Middleton Planning and Zoning Commission

Piccadilly Square Subdivision

RE: Piccadilly Square Preliminary Plat Review Comments

Floodplain comments
dated 3-1-2021

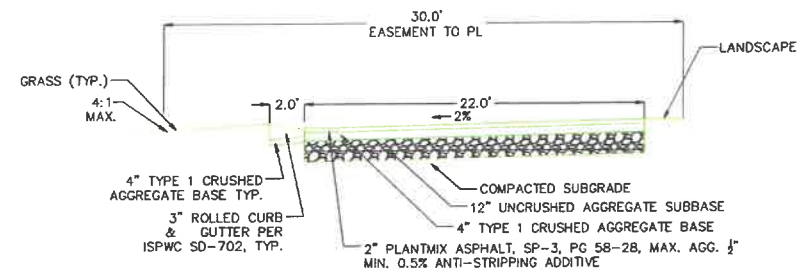
1. Penny Lane will have to be public road with a 50' radius belly turnaround for emergency access.
2. The two interior roadways may be private to access two houses each but driveways must be provided off of each one.

3. Extend western private roadway up to second house.
4. For the eastern private roadway you may want to consider accessing directly off Penny Lane instead.

5. Curb radii should be 25' out to Cemetery Road. Work with southern property owner to obtain R/W.
6. Change typical roadway section to 25' half width including same depth section. The paved roadway width should be 23' (17' travel lane + paving to the edge of pavement).

7. Extend waterline to end east end of Penny Lane then cap.
8. Pressurized irrigation line and pump station must be located outside of Penny Lane R/W.
9. Please verify BFE will be one foot above floodplain.

10. Add signed instrument numbers for all easements.
11. CC&Rs need to spell out how homeowners will maintain and ensure no alterations are made to bioswale.

12. Show necessary frontage improvements on Cemetery Road. Frontage improvements will include full depth pavement from centerline of Cemetery Road to end of each curb return.

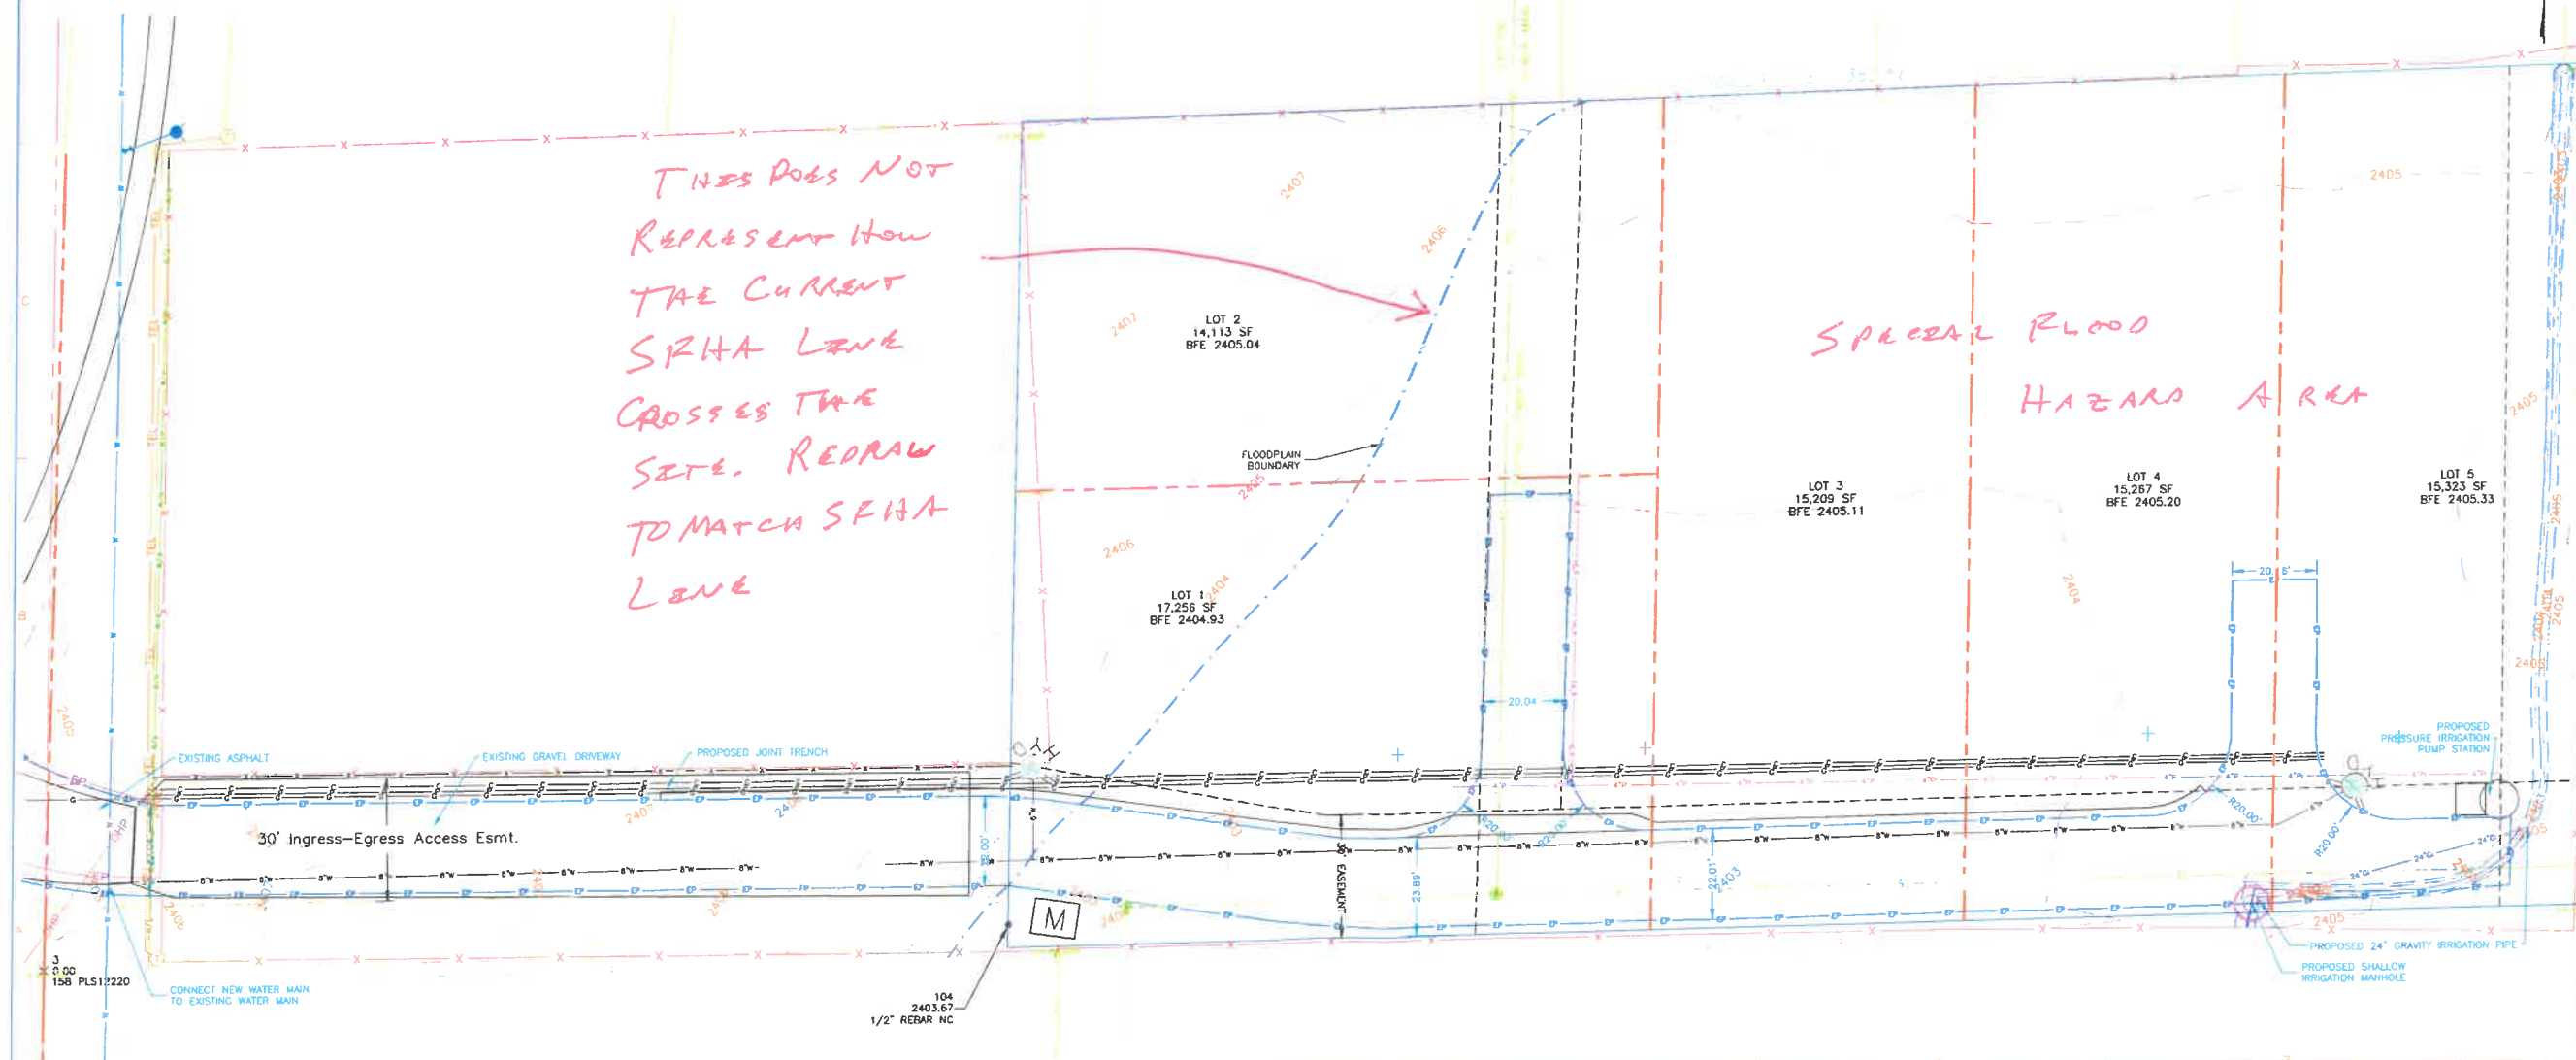
- ④ ADD A NOTE ABOUT LOTS IN THE WILLOW CREEK RIVERO PLAZA, REMA. PANEL #
AND THAT RESIDENTIAL ^{LOWEST} FLOOR MUST BE AT LEAST 1.0' ABOVE THE BFE FOR EACH LOT AS WELL AS A
BUILDING UTILITY ~~WATER~~ SYSTEMS.

⑤ ADD A NOTE THAT ELEVATION CERTIFICATES SHALL BE REQUIRED FOR ALL STRUCTURES IN THE SPECIAL FLOOD HAZARD AREA.

THIS DOES NOT
REPRESENT HOW
THE CURRENT
SEHA LINE
CROSSES THE
SITE. REDRAW
TO MATCH SEHA
LINE
